**RE: NMED SWQB Comments August 24, 2018 and EPA Comments September 26, 2018**

Enclosed you will find one (1) electronic copy of the revised Lee Ranch Mine (LRM) Use Attainability Analysis (UAA) report for the streams located in the vicinity of the LRM. The UAA report has been revised to address the technical review comments provided by New Mexico Environmental Department (NMED) Surface Water Quality Bureau (SWQB) on 8/24/2018 and Environmental Protection Agency (EPA) on 9/26/2018. Peabody Natural Resources Company (PNRC) believes that this UAA provides substantial evidence to support the modification of the designated use of the San Isidro Arroyo and its tributaries. Also accompanying this letter is PNRC's response to the technical review comments from NMED SWQB and EPA.

### NMED Surface Water Quality Bureau

### USEPA Region 6

## Lee Ranch Mine – Spring Photos

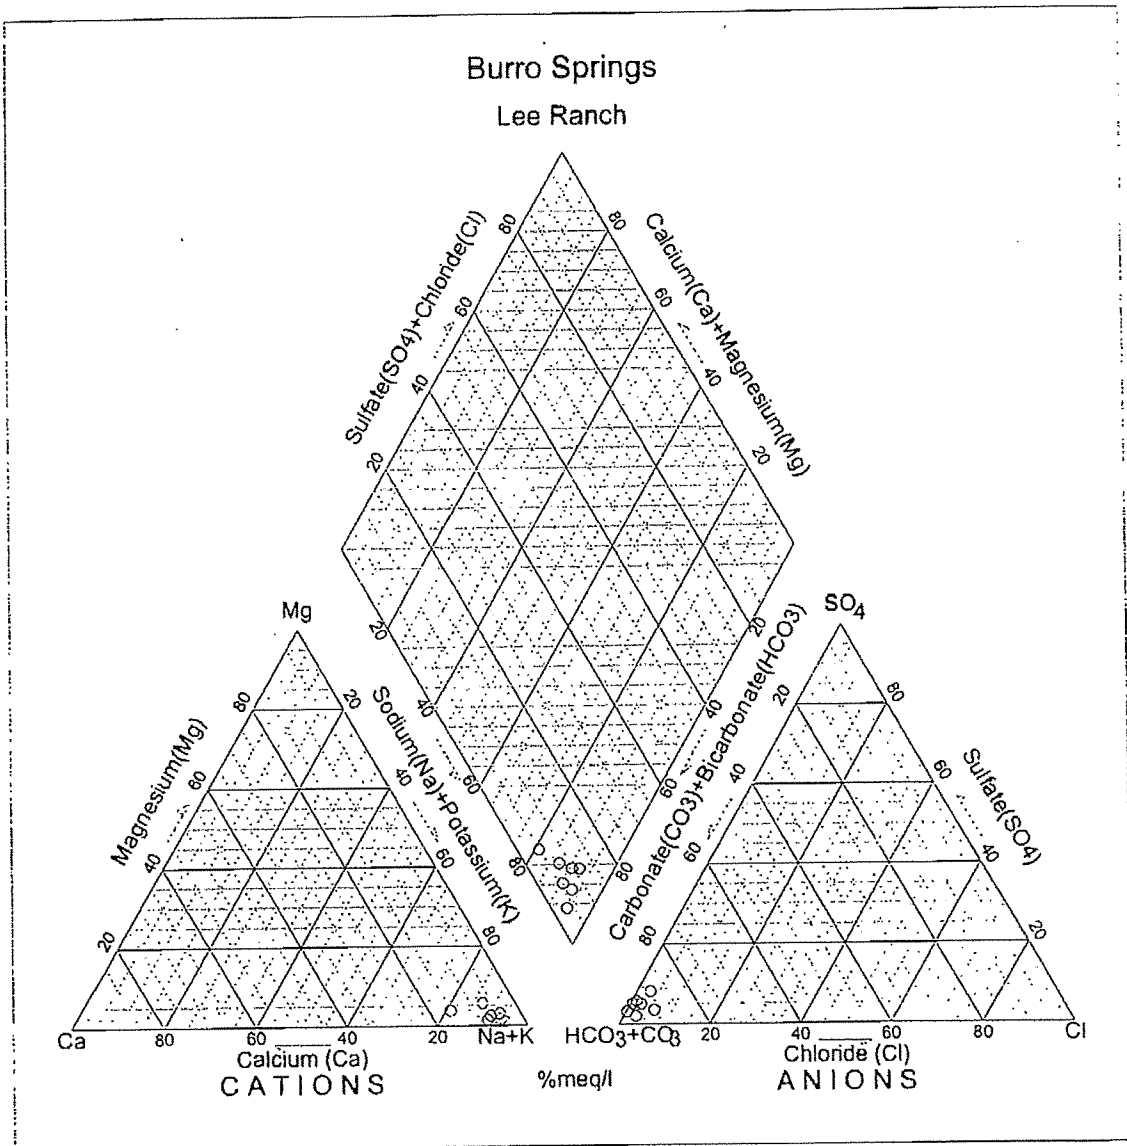
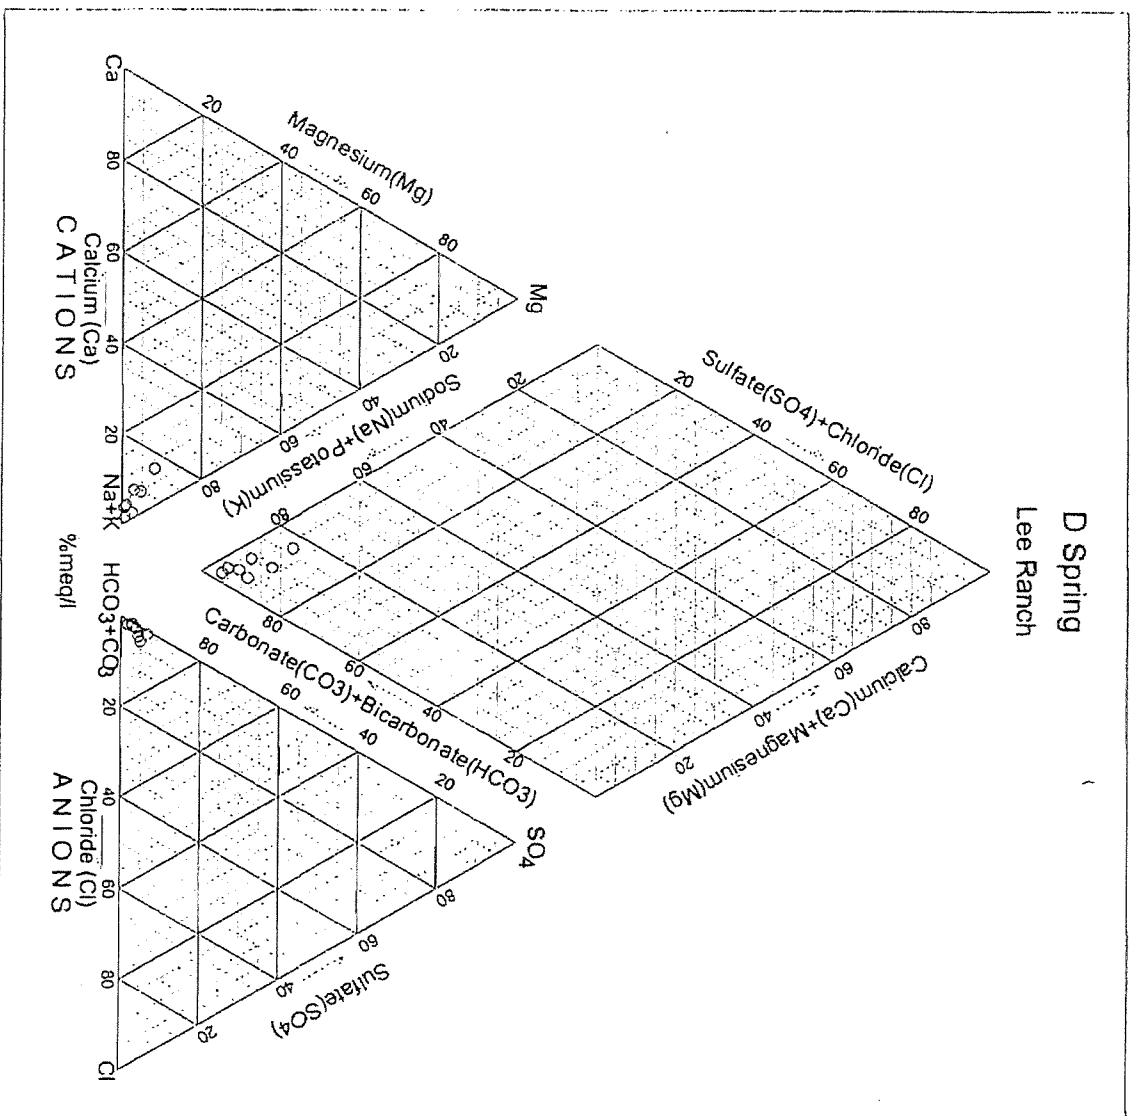
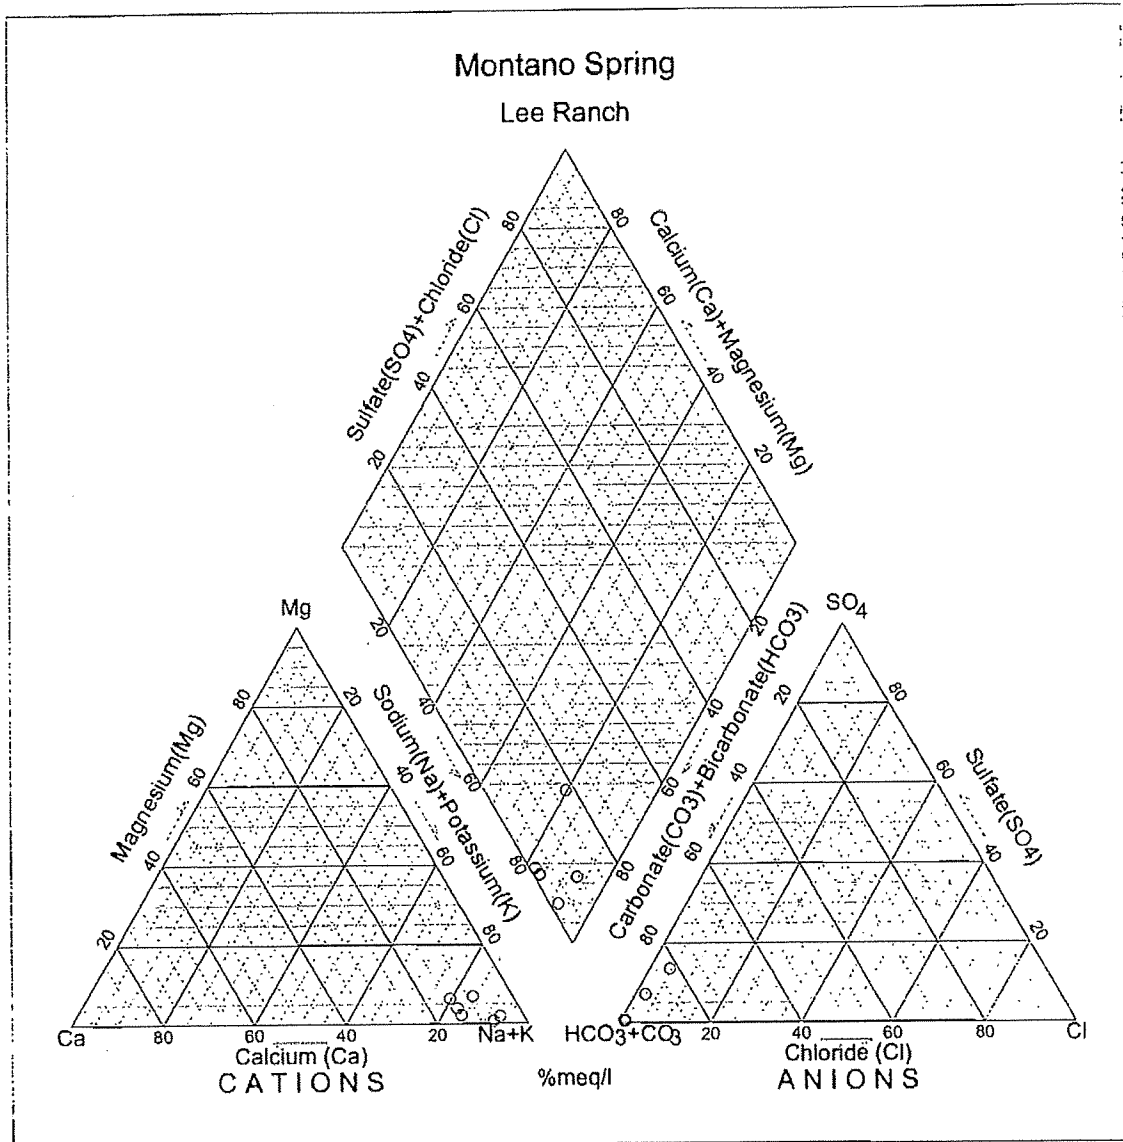
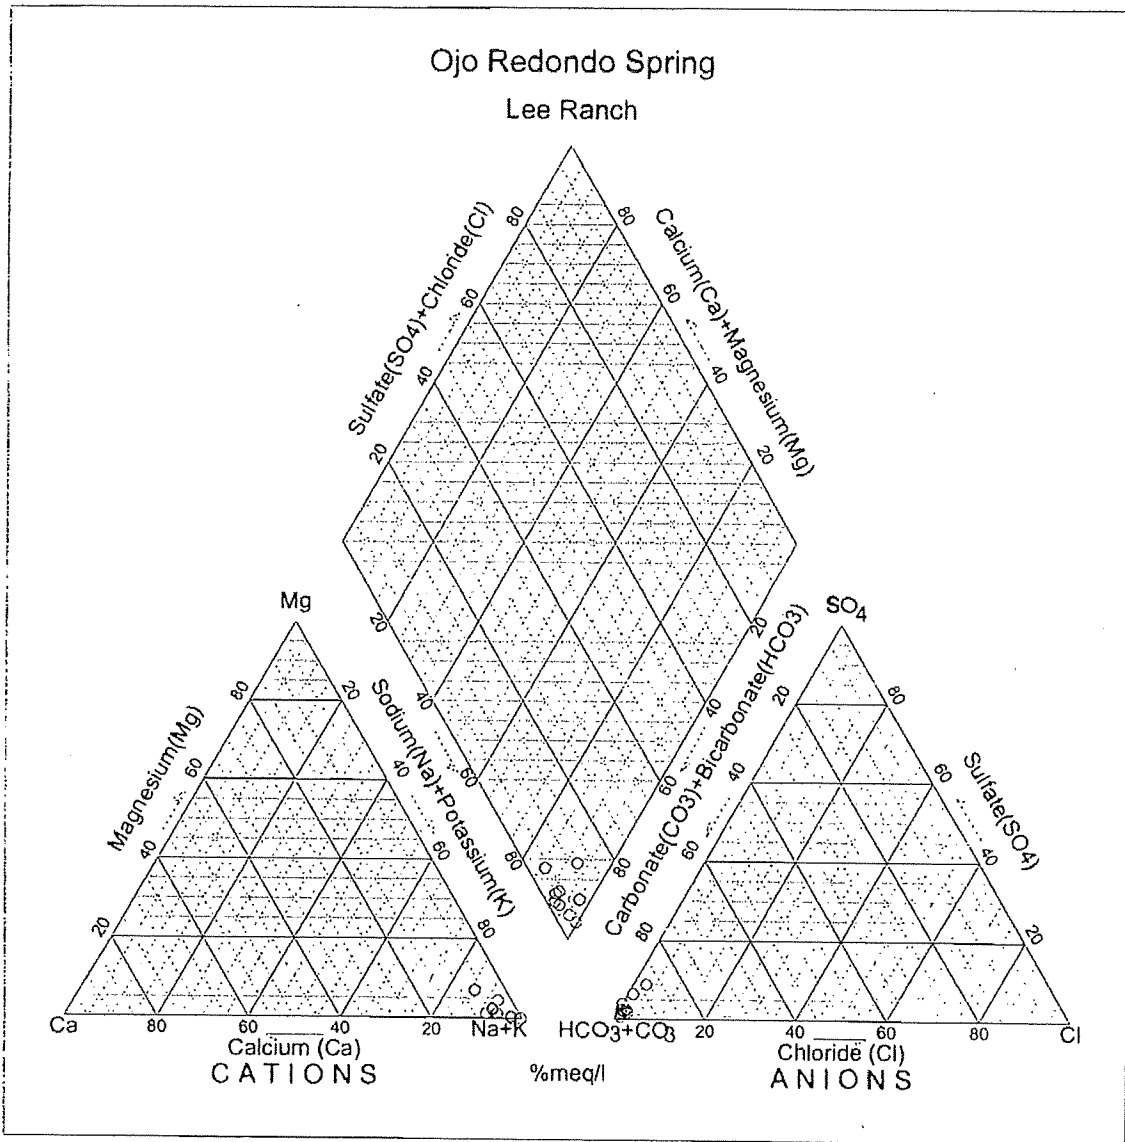
*The narrative indicates that some of these springs have intermittent or limited flow that may subside in a short distance, although some provide enough water for small livestock impoundments. It would be useful to have photographs of these springs for context.*
